## Sicherheitsmitteilung 030702

Herstellerbulletin: PSB CW03-01

Betrifft: Griffe und Pinne (Ripcord-Pin)

# Manufacturer Product Service Bulletin Number CW03-01

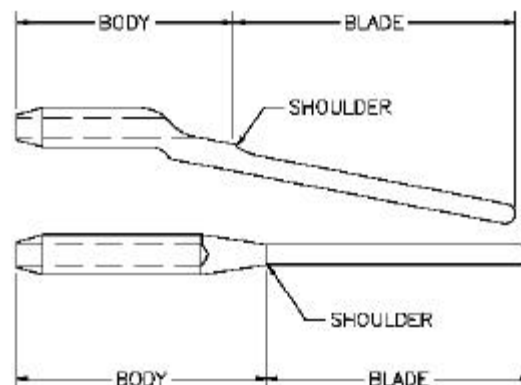
Alle vier sind ungefähr 1/8" (3 mm) vom SHOULDER am BLADE gebrochen.

Ein gebrochener Pin ist unten dargestellt.

Maßnahmen: Das Testen von betroffenen Pinnen nach Anweisung (siehe Beilage).  
Die Überprüfung ist eine einmalige, die nach Anweisung von Test1 oder Test2 lt. Herstellerbulletin PSB CW03-01 durch einen österr. Packer lt. §107a oder eine höherqualifizierte Person durchgeführt werden muss.

Broken Ripcord Pin

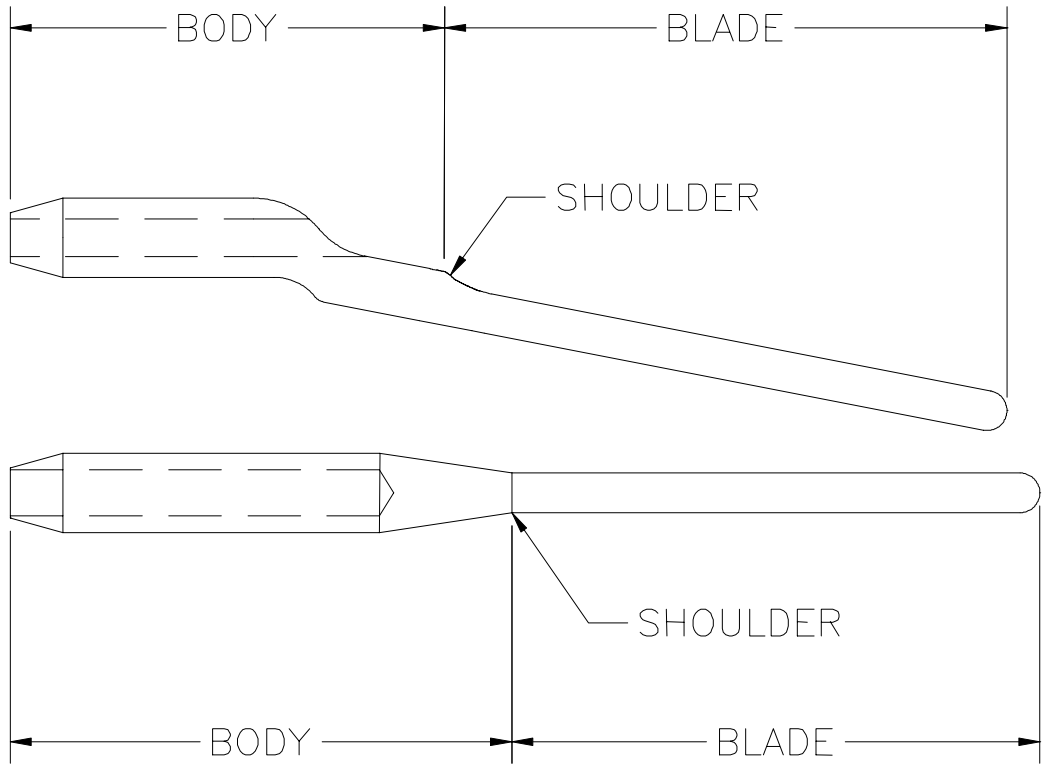
Capewell Components LLC has received (3) reports from (3) customers of (4) ripcord pins that broke. All (4) pins were reported to have broken under very low force. All (4) pins are reported to have broken on the blade section of the pin, approximately 1/8" (3 mm) from the shoulder of the pin. A broken pin is pictured below.

**FIGURE 3**  
All dimension in inches

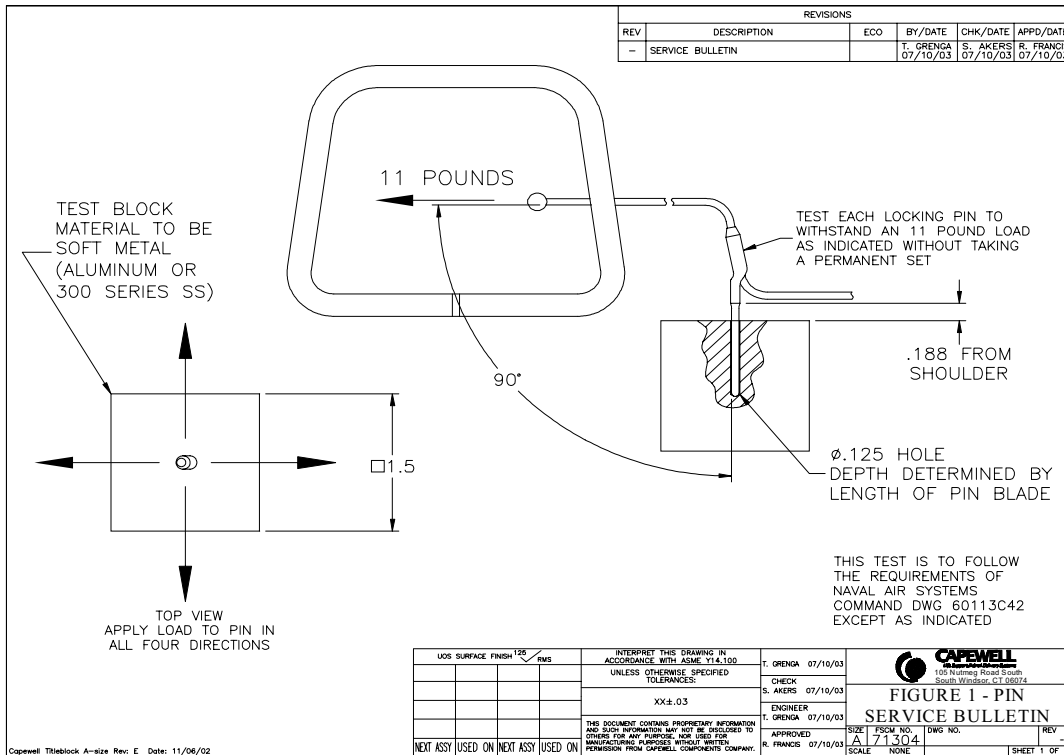
1. Place pin in test block per Figure 3 (below). NOTE: The pin block hole may be VERTICAL or HORIZONTAL
2. Apply 11 lb. force 90 degrees perpendicular to the pin blade.

3. Remove pin from block and inspect:
  - For straightness: Pins in excess of .005 (.12 mm) deformation along the blade of the pin should be removed from service.

foto č. 1

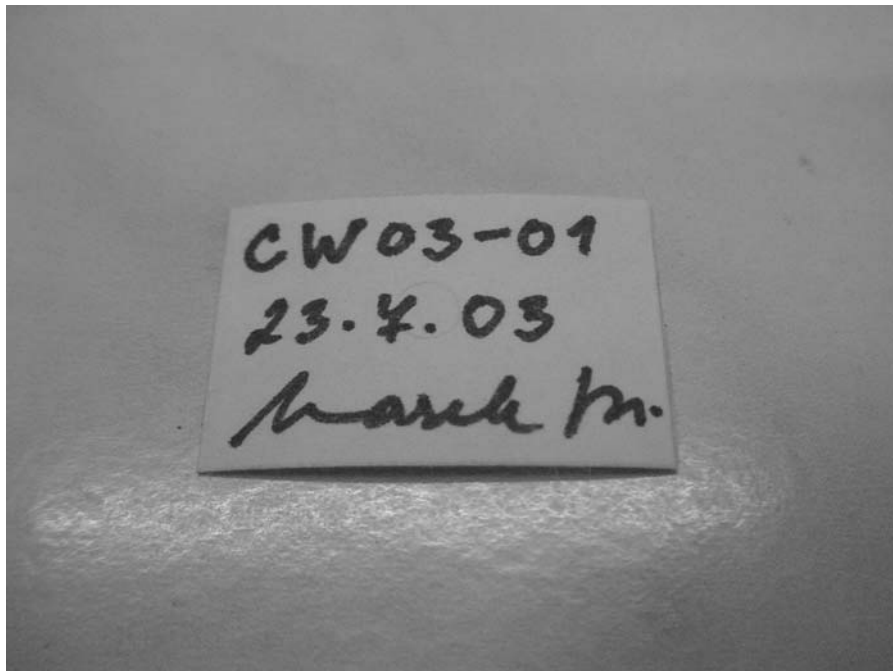
- b) The handle of the release device must be marked CW 03-01, alternatively including date and signature.

We recommend the marking the handle with a self-adhesive plate with required inscriptions; if need be, the plate can be stuck all over with a transparent adhesive tape attached up to the area that has minimal resistance to abrasion and that is visible even when the release is hidden in a pocket. In emergency, the release can be marked with a permanent highlighter/marker.
